MONITORING YEAR 2 ANNUAL REPORT

ALEXANDER FARM MITIGATION SITE

RE: Draft Year 2 Monitoring Report
Alexander Farm Mitigation Site, Alexander County
Yadkin River CU 03040101
DMS Project ID No. 100022 / DEQ Contract #007186

Wildlands Engineering, Inc. (Wildlands) has reviewed the Division of Mitigation Services (DMS) comments from the Draft Year 2 Monitoring Report for the Alexander Farm Mitigation Site. The report has been updated to reflect those comments. The Final MY2 Report is included. DMS' comments are listed below in **bold**. Wildlands' responses to DMS' comments are noted in *italics*. Comments received via email on January 4, 2022 are also included.

Figure 3.3 Current Condition Plan View
 Alexander Farm Mitigation Site
 DMS Project No. 100048
 Monitoring Year 2 - 2021
 Alexander County, NC

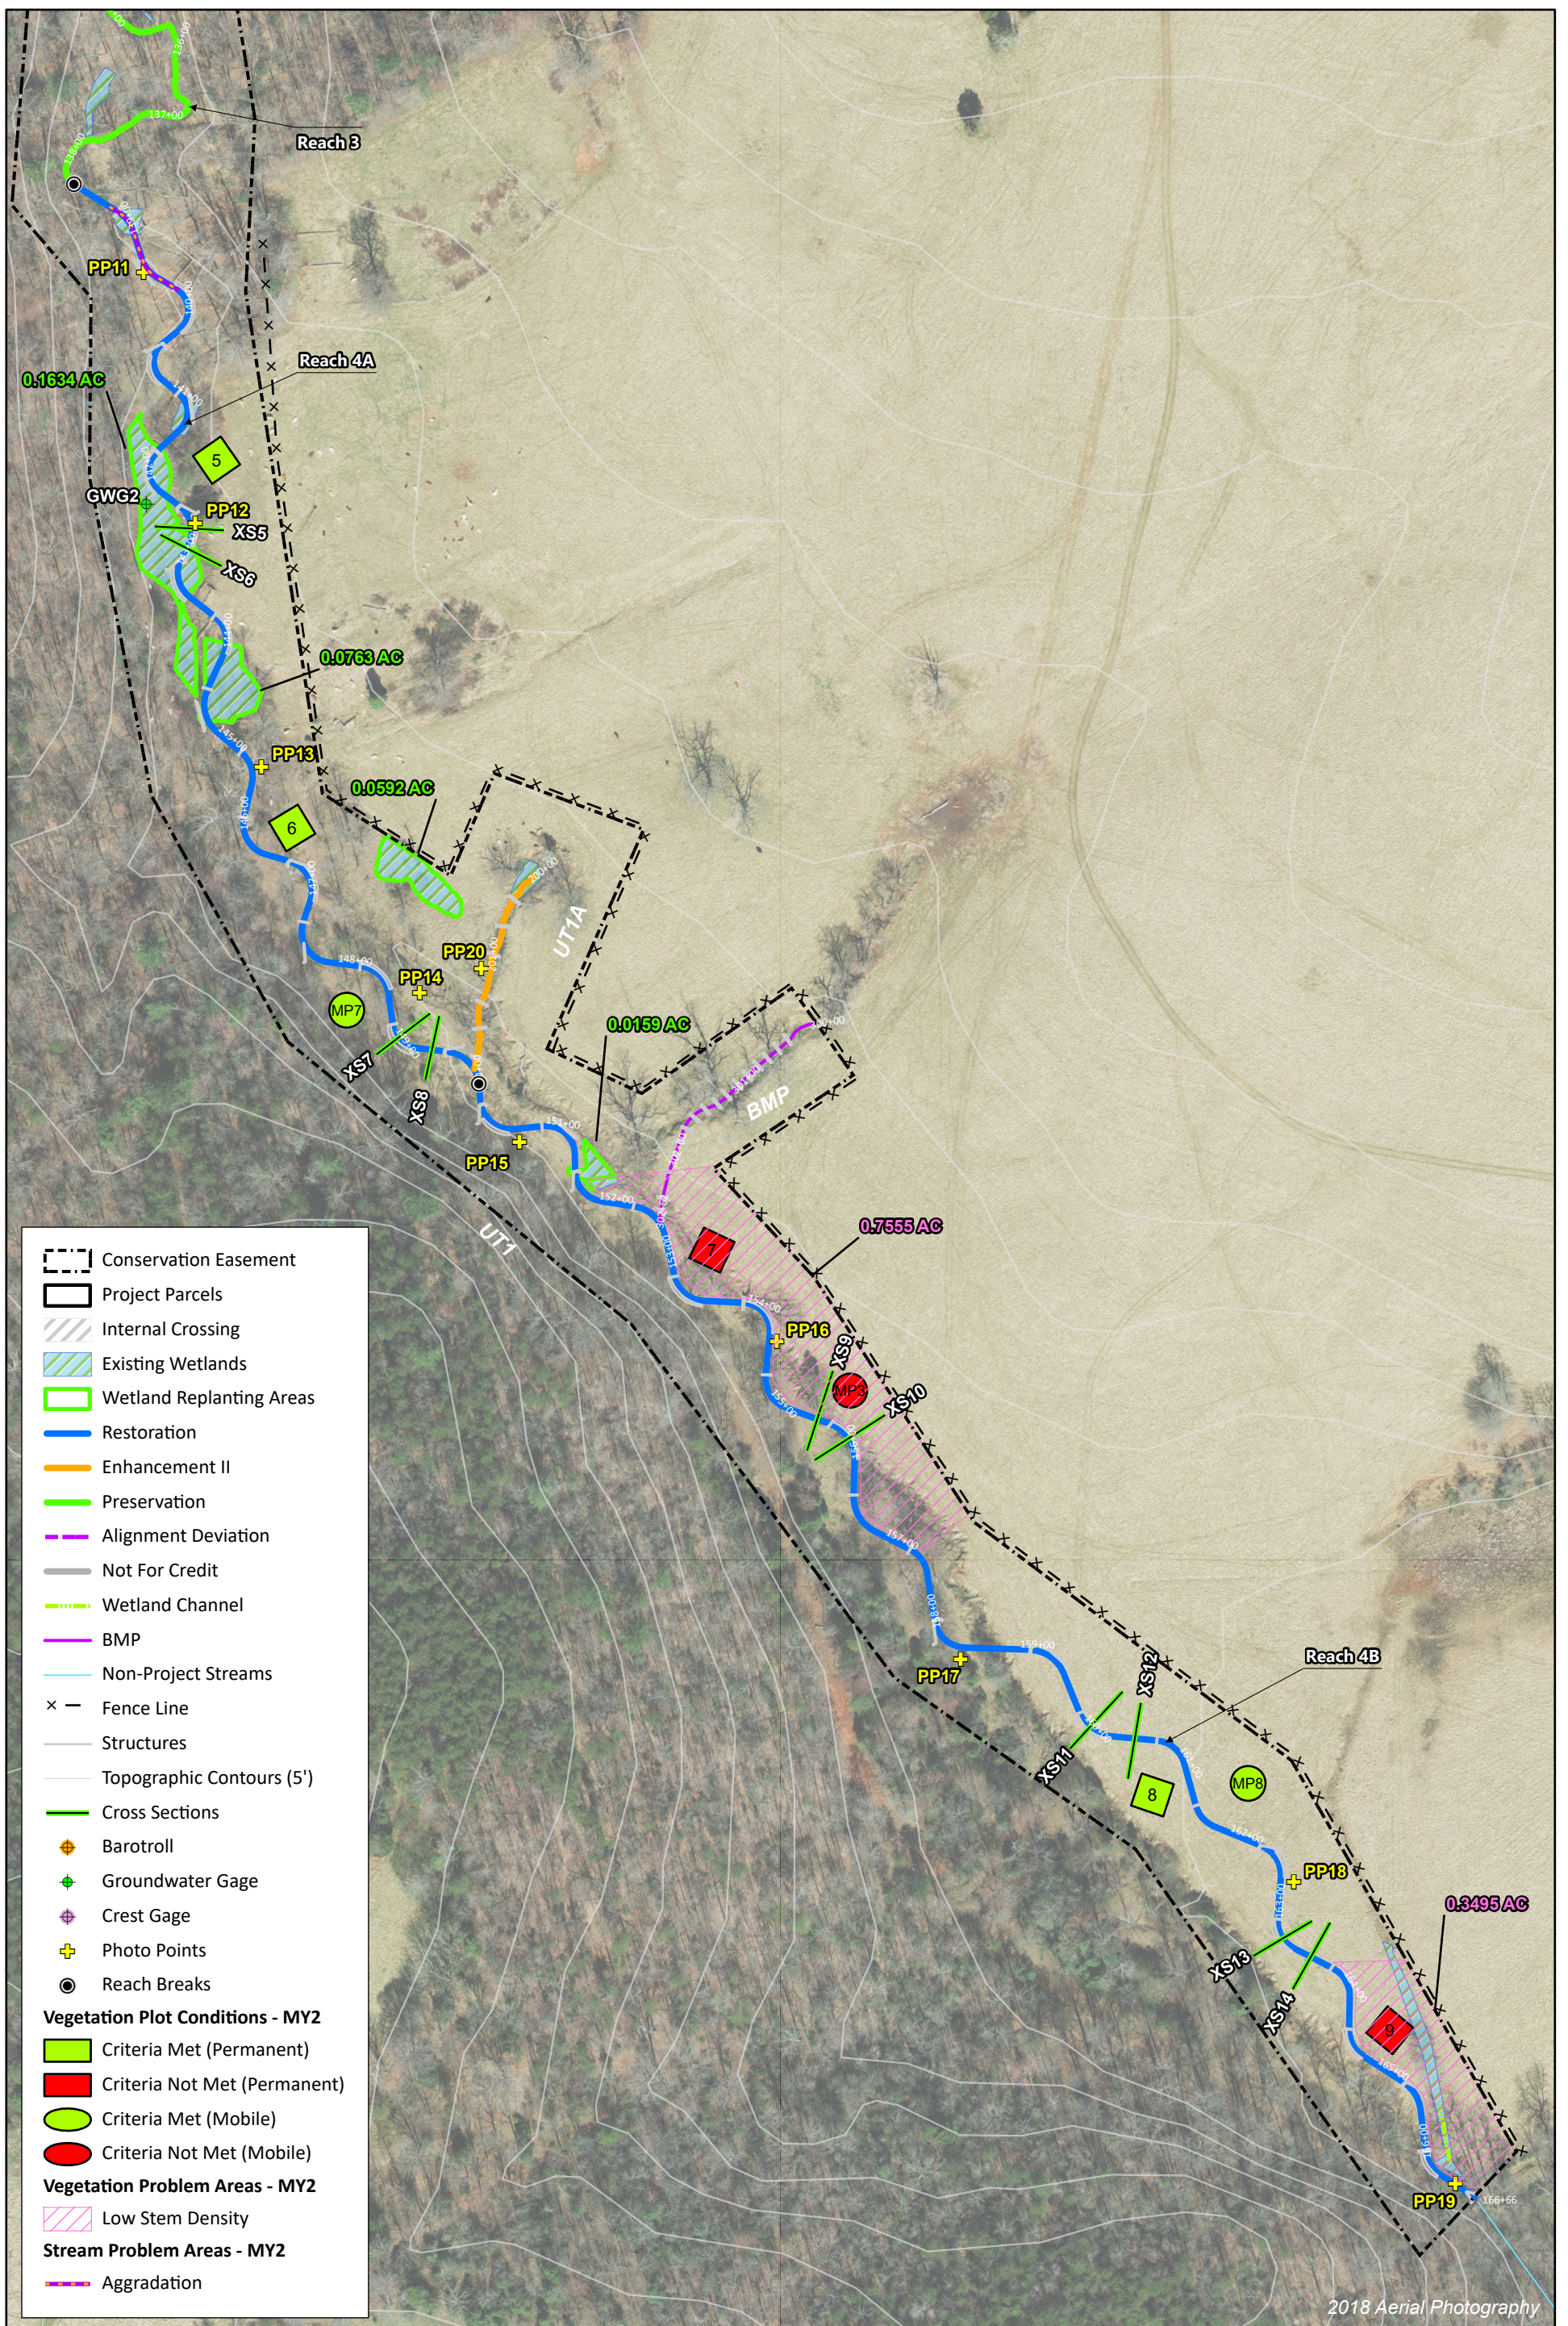
DMS' comment: There is a "bankfull" line on the CCPVs (thick dashed line), it is recommended removing this unless it serves a specific monitoring function on the maps.

DMS' comment: What is meant by "alignment deviation" on the CCPVs? Does this mean there has been significant lateral migration of the channel? If there is an issue with this it should be identified appropriately and discussed in the report in addition to being mapped.

Wildlands' response: Wildlands has removed the "bankfull" line from the CCPVs.

Wildlands' response: There is no issue with the channel in this area. The alignment deviation that is shown on the CCPV maps represents the as-built channel alignment and how it differs from the design alignment.
